LBL 75.92 LONGITUDINAL FLOOR BEAM FROM STA 1290 TO STA 1318 DEBRIS FIELD GREEN

LOG T LF 126

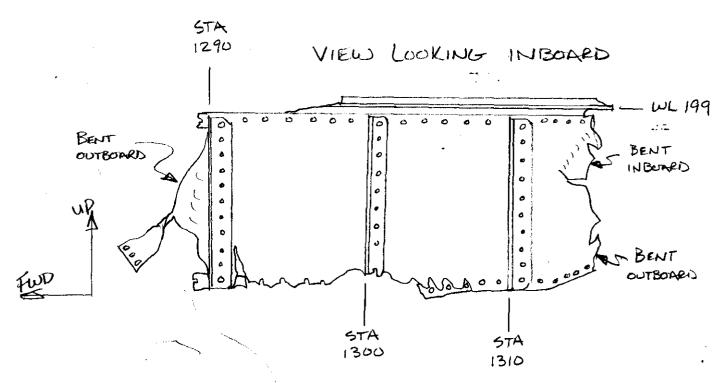
- * THERE ARE INDICATIONS OF MEDIUM TO HEAVY SOUTING ON BETH INBOARD AND OUTBOARD SIDES.
- * LOWER CHOED HORIZONTAL FLANGE IS MISSING
- * LOWER CHORD VERTICAL FLANGE PULLED OUT OF WEB AND SEPERATED FROM REMAINING LOWER CHURD FROM STA 1290 TO STA 1305.
- * THERE ARE NO INDICATION OF PENETRATIONS IN WEB. "
- 4 THERE IS A TAR LIKE SUBSTANCE ON THE LOWER SUFFACE OF THE REMAINS UPPER CHOEN IBRIZONTAL FLAND AND THE UPPER EDGE OF THE WEB ON THE OUTBOARD SIDE ONLY.
- * THERE ARE DARK SPLATER MARKS ON THE OUTBOARD WEB SECTION FORWARD OF STA 1290
- THE FORWARD SIDE OF THE VERTICAL STIFFENERS

Numberlings JAM CHOED TO THE LOWER CHORD,
